24 volt Trolling Motors with Gator Flex 360 Mount Improvement

Models Covered	Serial Number
24 volt, 71 lb. Thrust Hand & Foot Operated Salt and Fresh Water Gator Flex 360 Models	9B320181 through 9B822722

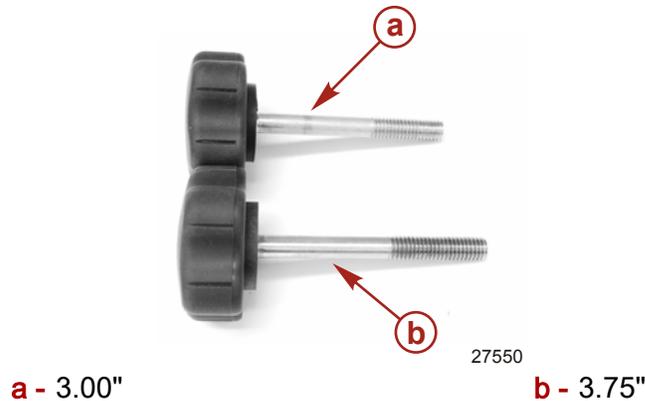
The holding ability of some isolators used on the Gator 360 mounts with 24 volt motors has not met the standards of MotorGuide.

REPLACING ISOLATOR ONLY - KIT NUMBER 8M4000305

1. Open the door and remove the existing isolator.
2. Install the new isolator components into the mount **without** the motor and fully close the door to preset the isolators into the mount.
3. Reopen the door and install the motor.
